RE: Sunfish Lake – Planning Update for August City Council Meeting

PLANNING REPORT - Major Site and Building Plan Review & CUP

RE: Sunfish Lake – 8 Roanoke Road – Site and Building Plan Review & CUP

PLANNING REPORT – Site and Building Plan Review & CUP Addendum

EXTA Lighting Plan
8 Roanoke
SUNFISH LAKE, MN
1/8" SCALE

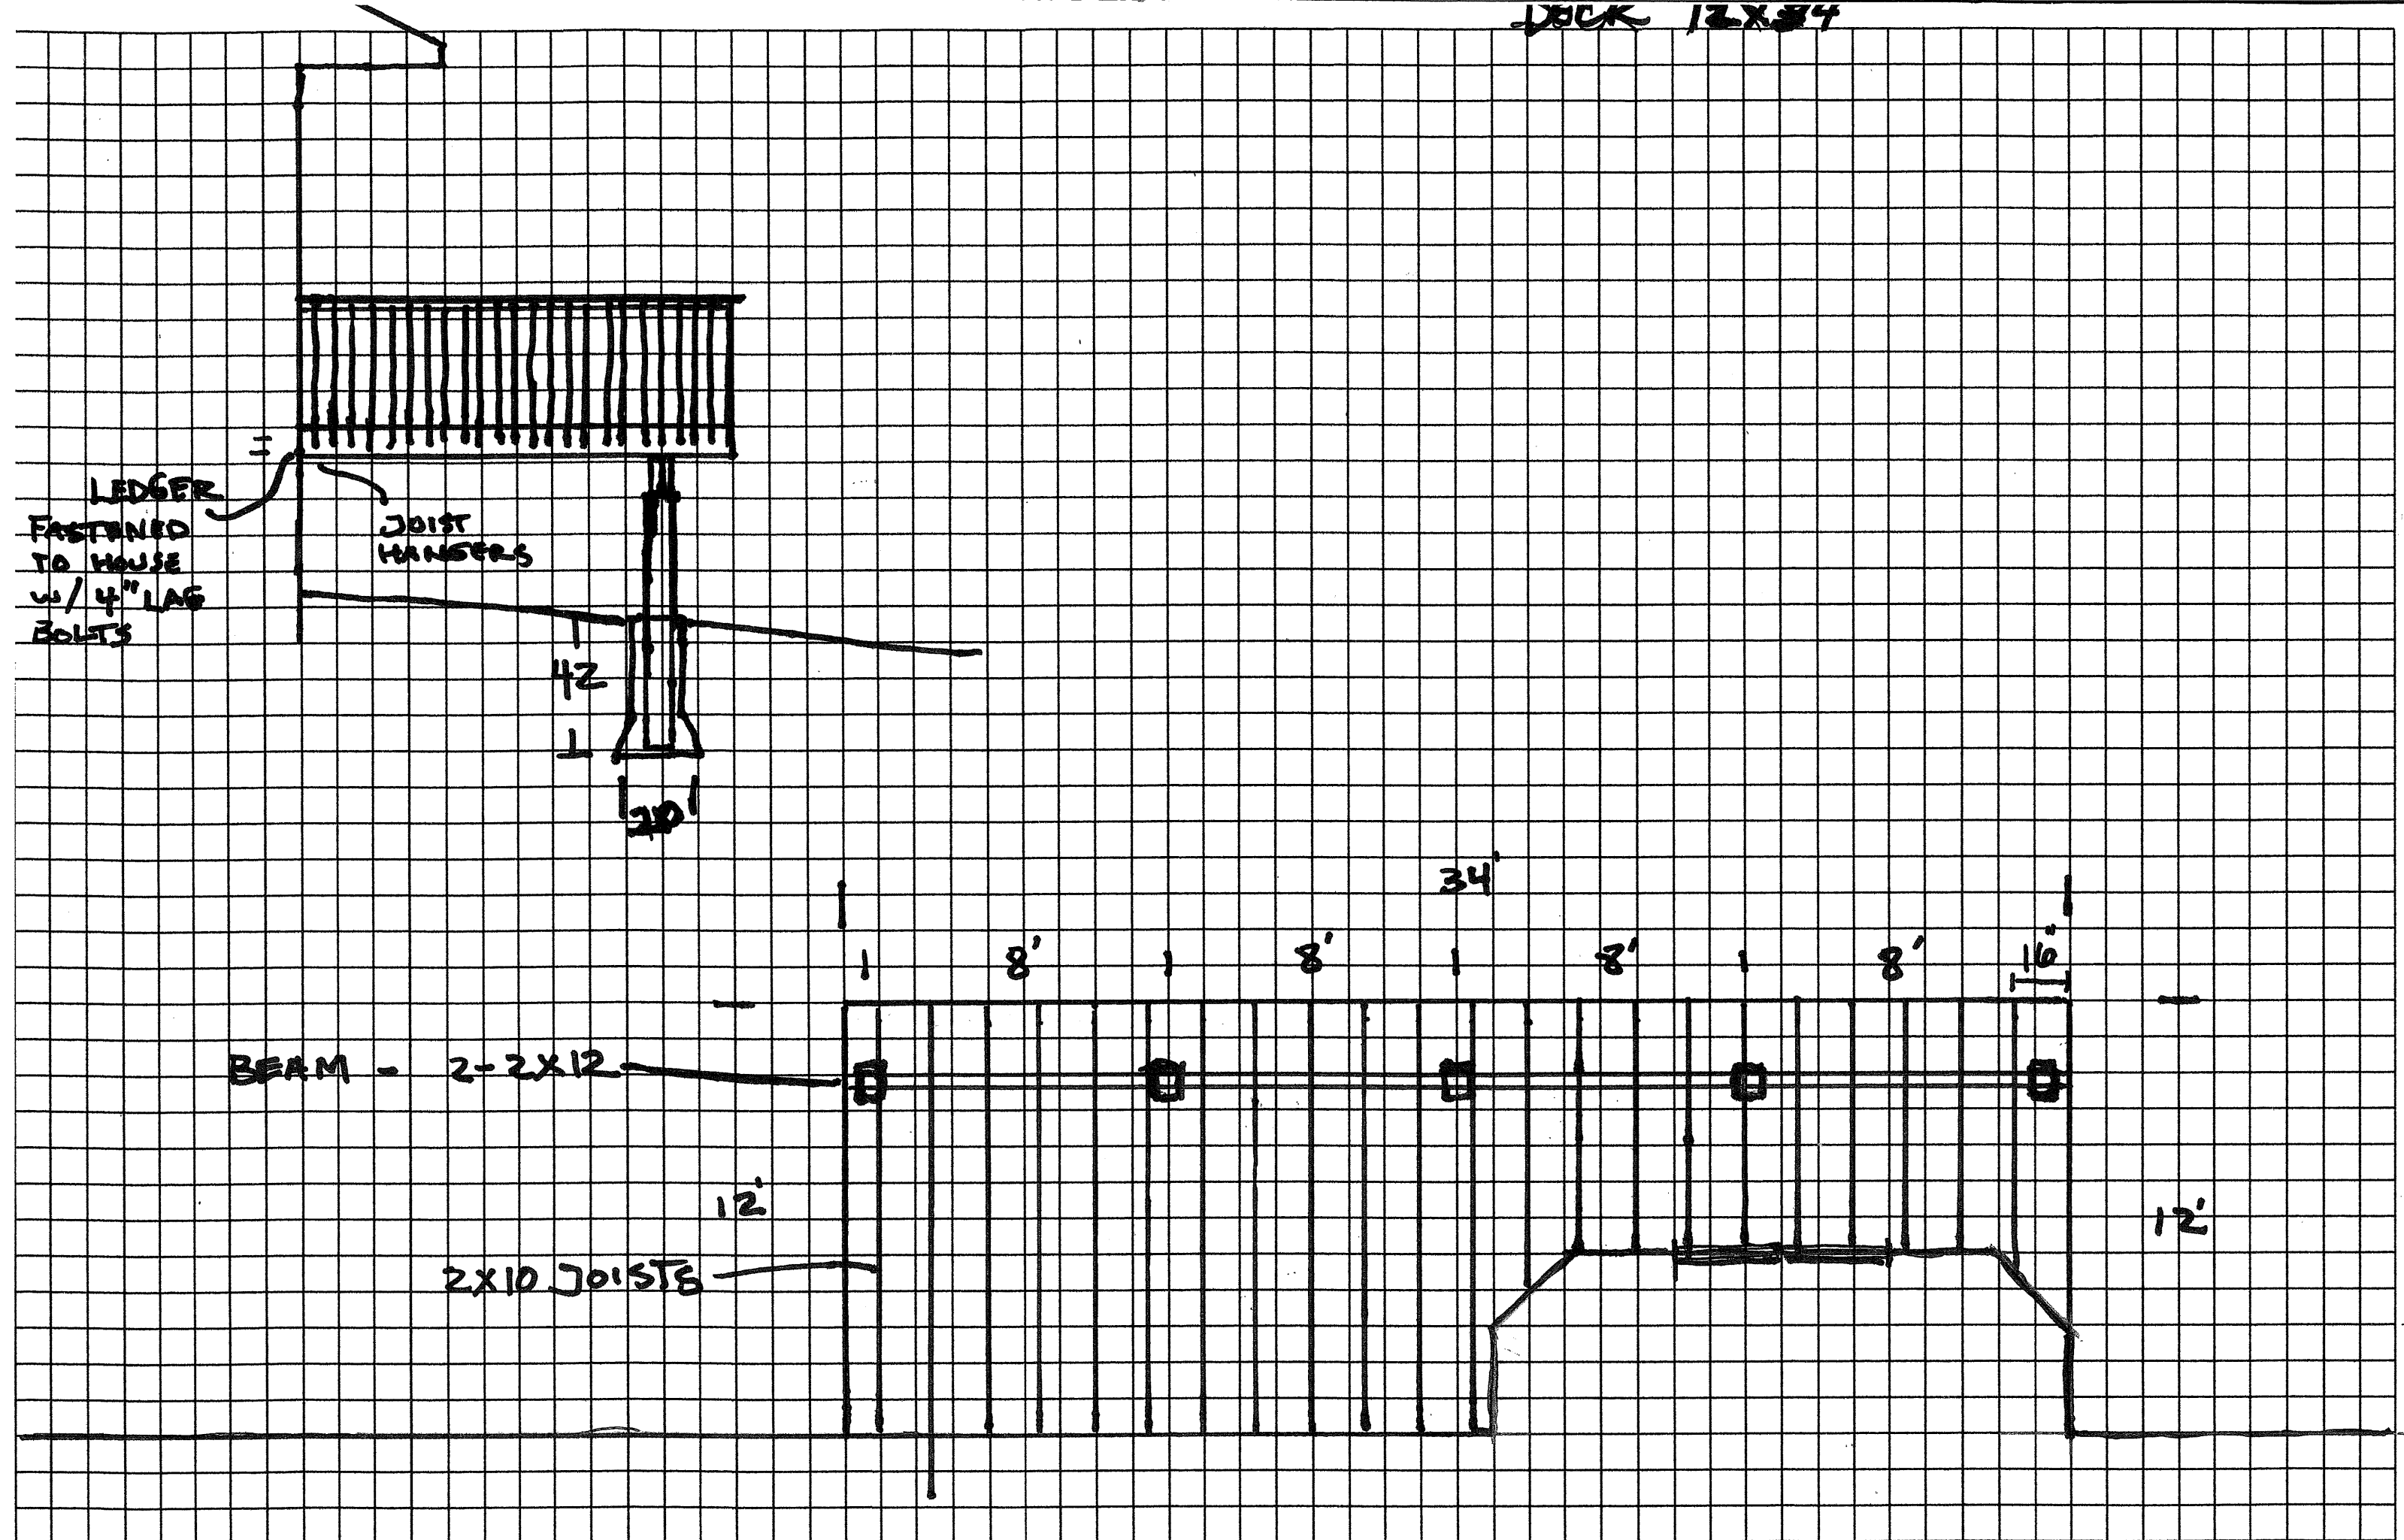
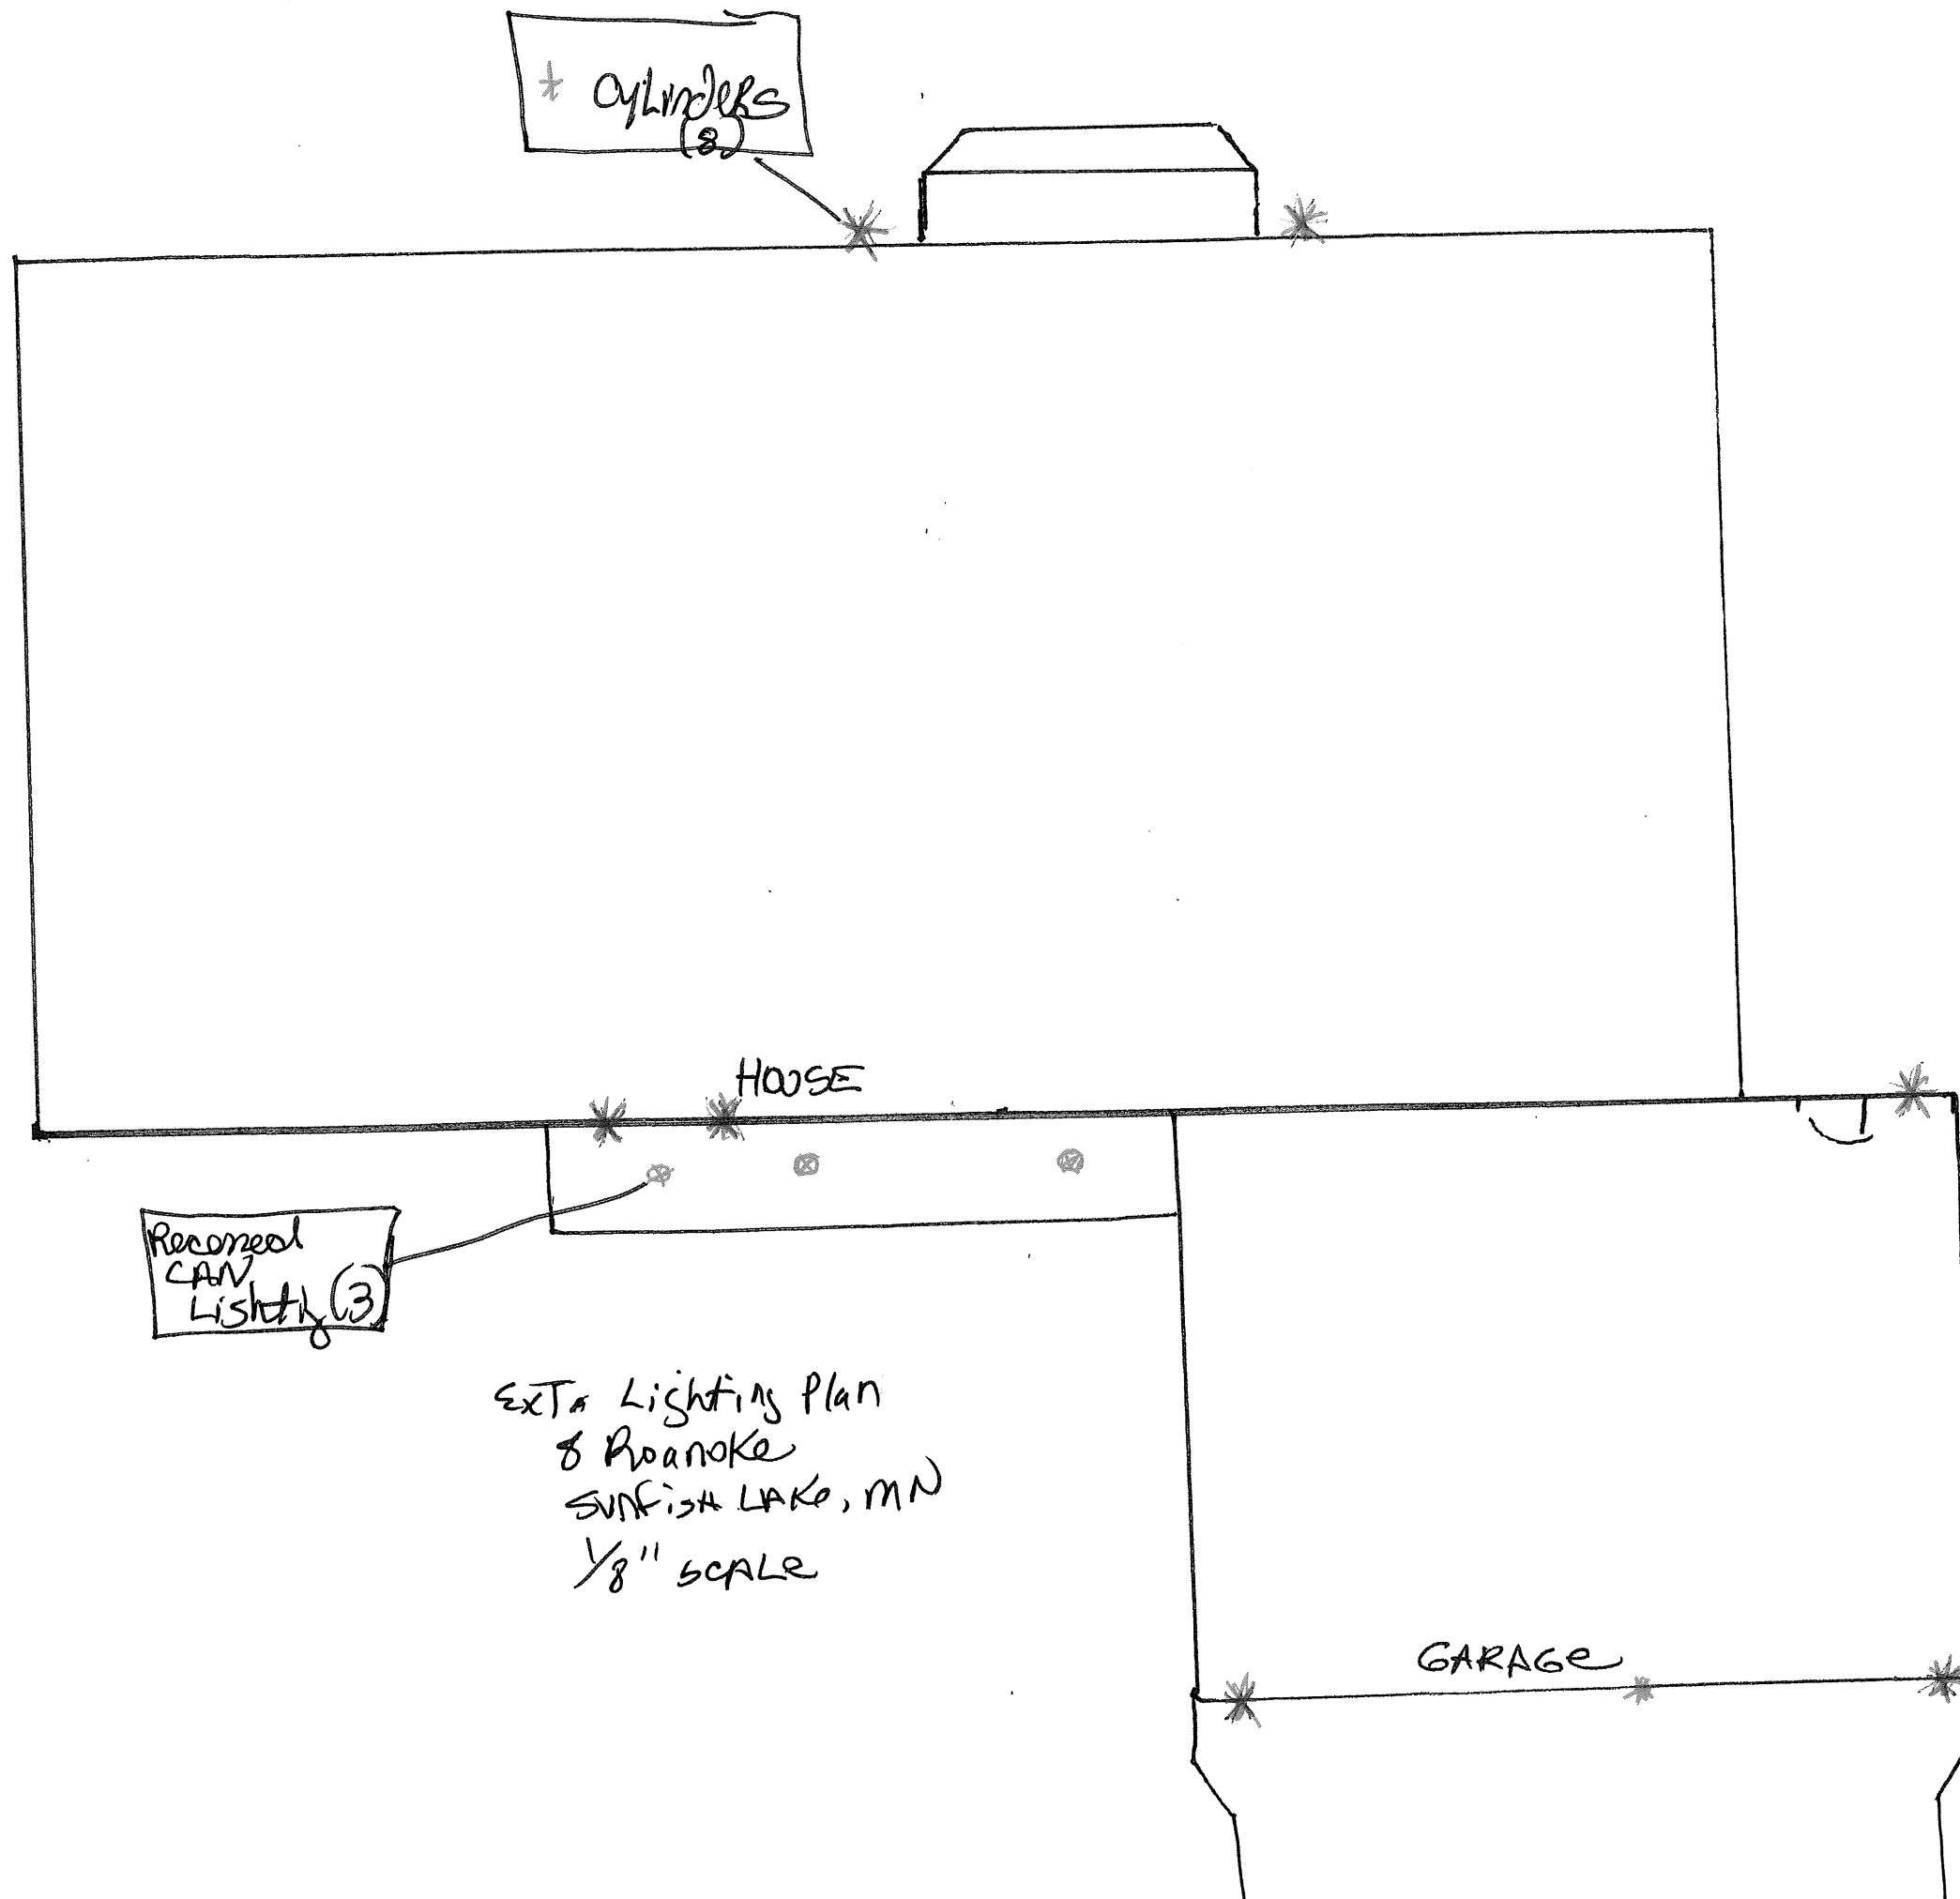
The applicants' exterior lighting plan includes eight cylindrical outdoor wall lights (located at the front entrance, around the garage, and above the proposed deck), and three recessed soffit lights (located above the front porch). The proposed cylindrical wall lights are neither hooded nor recessed, and do direct light upwards. Additionally, they do not appear to provide fogged glass to reduce the sky-reflected glare. However, the cylindrical lights are relatively small in size (12" height by 4" width) and use moderate wattage (60w), and as such the applicants are requesting consideration of the fixtures by the Planning Commission. If the Planning Commission deems the cylindrical

lights as inappropriate, the applicants are requesting consideration of an alternative hooded light fixture. The second wall light option is a bit larger (14" height by 7" width), but provides a black hood and milked glass, features which will help to control glare. The proposed soffit lights are recessed and provide albalite lens to help diffuse light, and as such meet all ordinance requirements pertaining to outdoor lighting.

2. The applicants shall provide proof that upon completion of installation of lights, all lights or combination of lights which cast any light on residential property do not exceed one foot candle (meter reading) as measured from adjacent property lines. This may be demonstrated by providing evidence of at which distance out from proposed light fixtures meter readings will fall below the required one foot candle measurement.
